**DATE:** July 26, 2024  
**PAGE:** 1 of 16 (INCLUDING THIS PAGE)  
**TO:** ALL CONTRACTORS  
**FROM:** DENISE KING  
**PROJECT:** NEW LOXLEY WATER TREATMENT PLANT  
FOR THE CITY OF LOXLEY  
GMC PROJECT NO. CMOB220078(2)  
**RE:** ADDENDUM #3

# ADDENDUM NUMBER 3

NEW LOXLEY WATER TREATMENT PLANT

- 2.1 Specification 40 71 13 – Magnetic Flow Meters has been revised and is included as an attachment to this addendum.
- 2.2 Drawings E-912, E-913, I-101 & I-601 have been revised and are included as an attachment to this addendum.

**I-601**

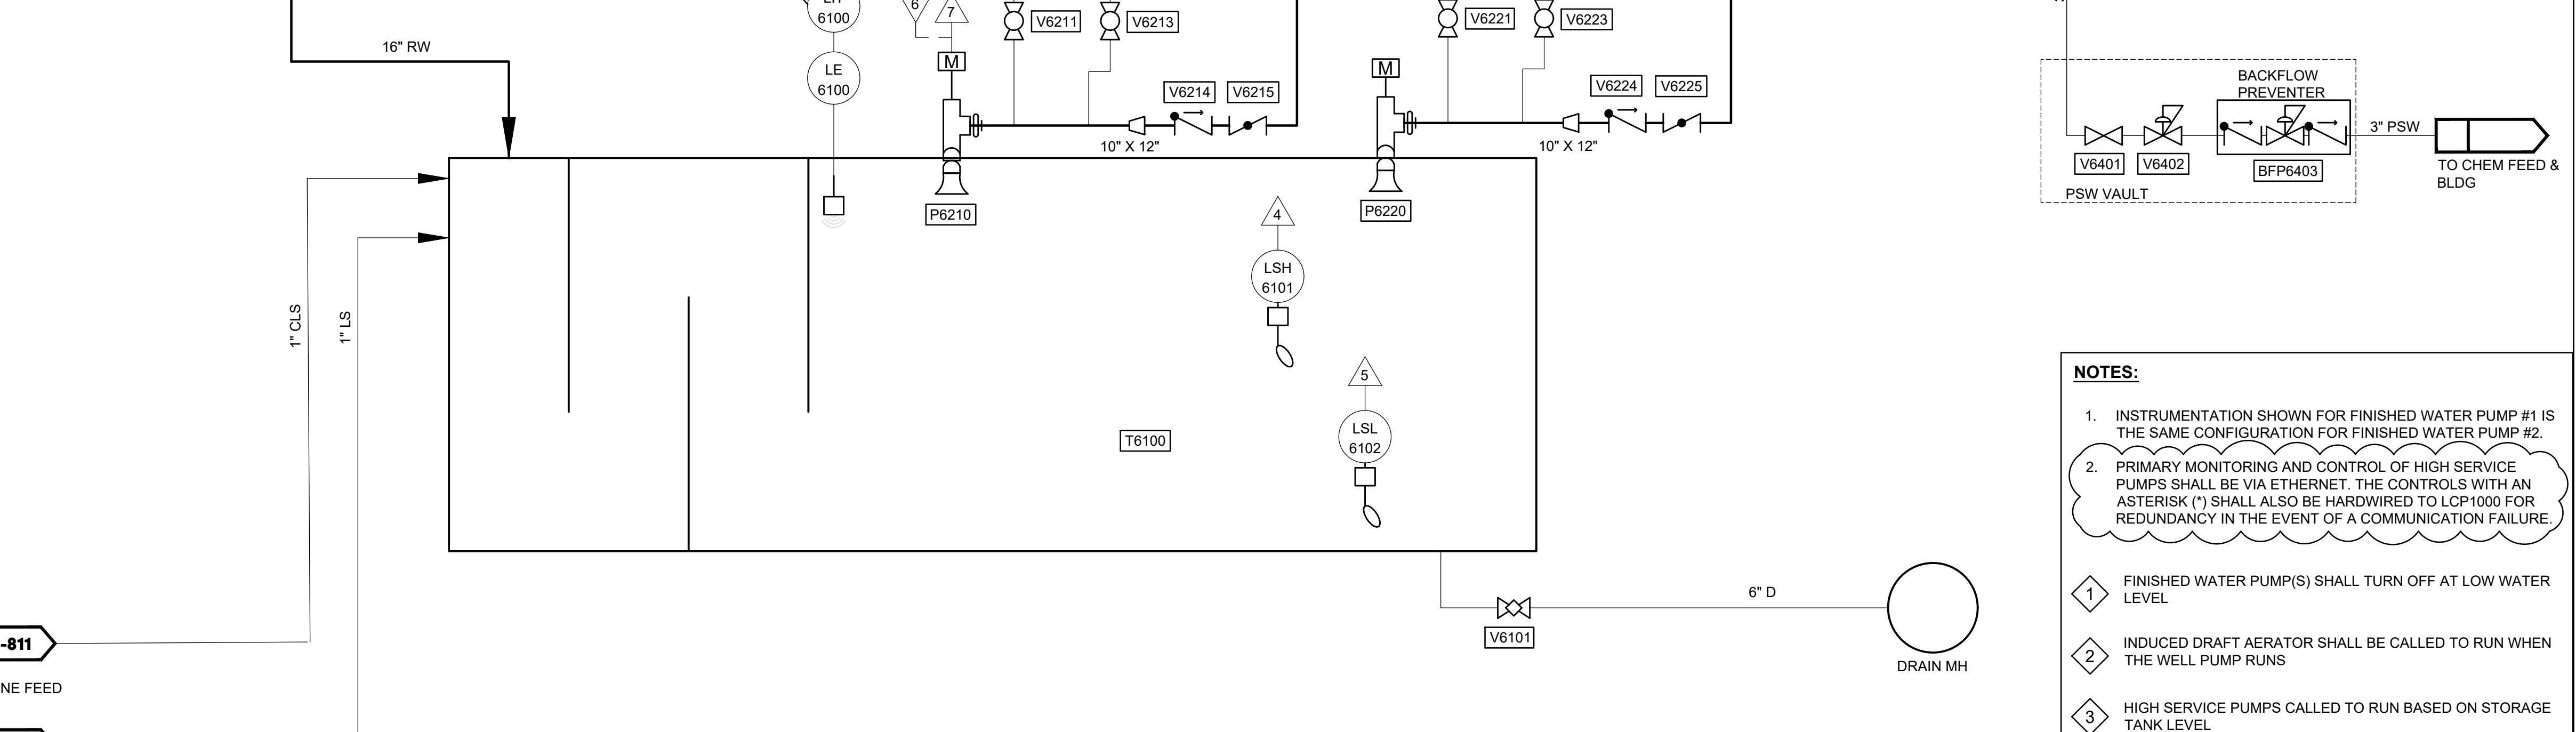
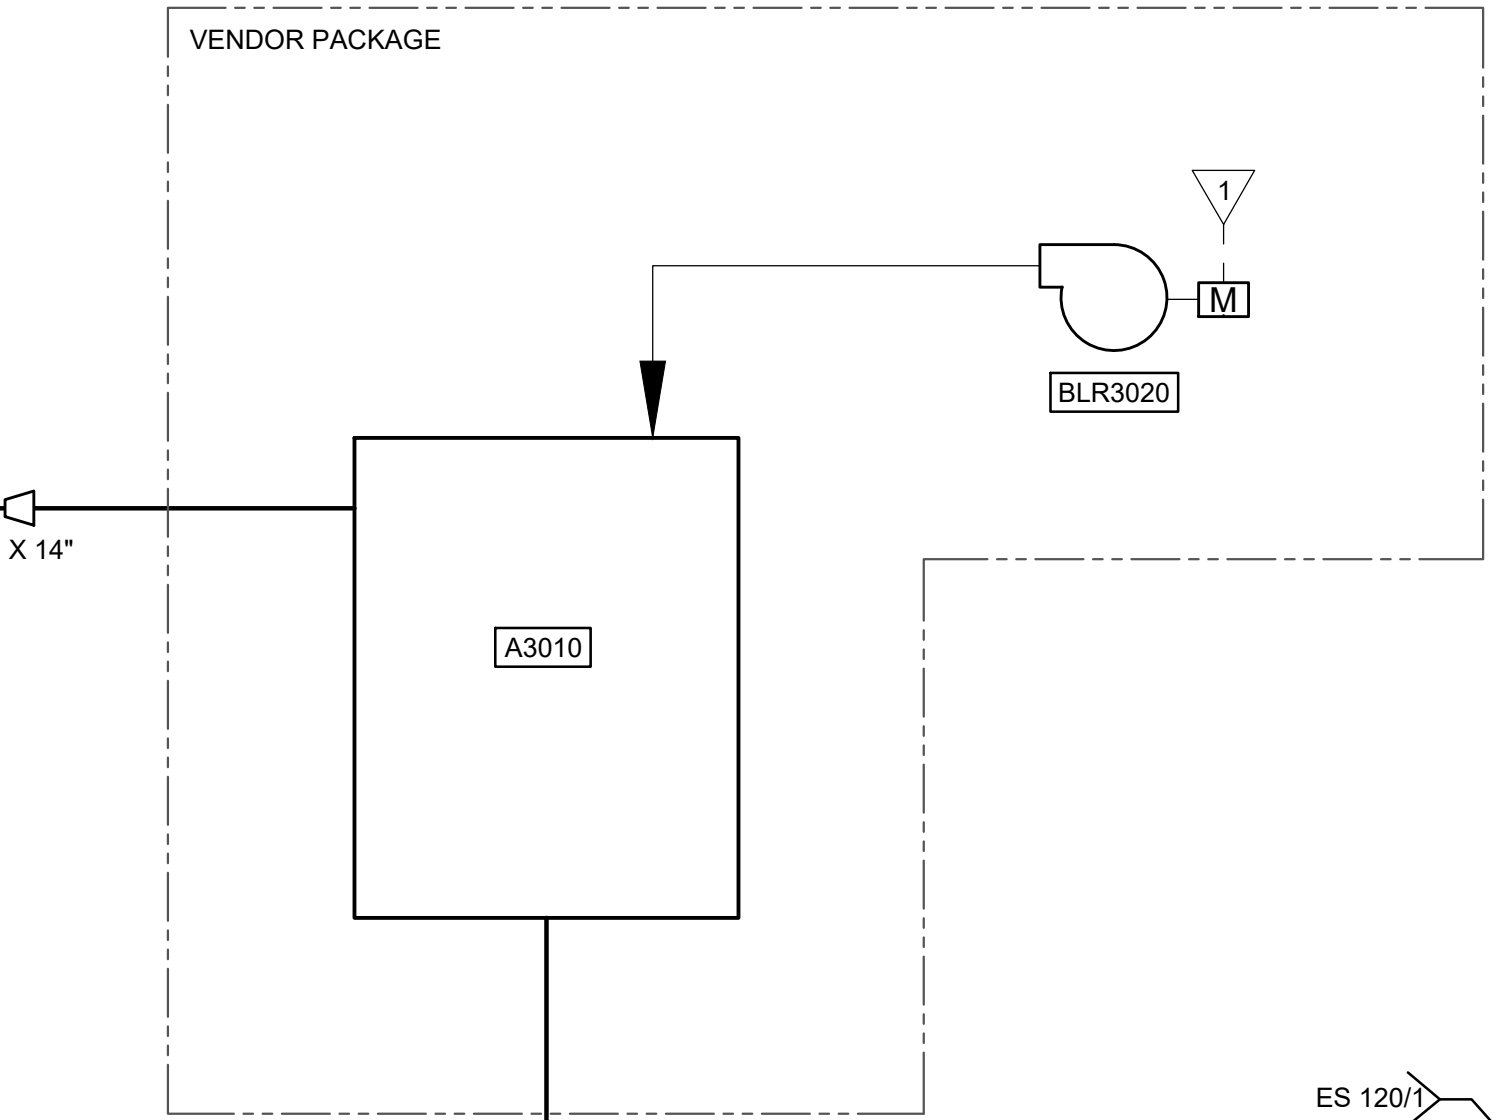
Answer: The only mag meter in the project is FE/FIT1100. The revised specification is included as an attachment to this addendum.
- 3.2 **Question: PSH6211 & PSH6221 are shown on SHT I-601 but are not listed in the specifications. Please confirm that specification 40 73 36 & 40 73 63 apply to these pressure switches.**

Answer: Yes, Specifications 40 73 36 & 40 73 63 apply to these pressure switches.
- 3.3 **Question: PI1104 on SHT I-101, PI6211 on SHT I-601, & PI6221 on SHT I-601 are not listed in the specifications. Please confirm that Specification 40 73 13 & 40 73 63 apply to these instruments.**

Answer: Yes, Specification 40 73 13 & 40 73 63 apply to these instruments.
- 3.4 **Question: PI8003 on SHT I-801 & PI8103 on SHT I-811 are not listed in the specifications. Please confirm that specification 40 73 13 applies to these instruments**

- NOTES:**
- INSTRUMENTATION SHOWN FOR FINISHED WATER PUMP #1 IS THE SAME CONFIGURATION FOR FINISHED WATER PUMP #2.
  - PRIMARY MONITORING AND CONTROL OF HIGH SERVICE PUMPS SHALL BE VIA ETHERNET. THE CONTROLS WITH AN ASTERISK (\*) SHALL ALSO BE HARDWIRED TO LCP1000 FOR REDUNDANCY IN THE EVENT OF A COMMUNICATION FAILURE.
- 1 FINISHED WATER PUMP(S) SHALL TURN OFF AT LOW WATER LEVEL
  - 2 INDUCED DRAFT AERATOR SHALL BE CALLED TO RUN WHEN THE WELL PUMP RUNS
  - 3 HIGH SERVICE PUMPS CALLED TO RUN BASED ON STORAGE TANK LEVEL
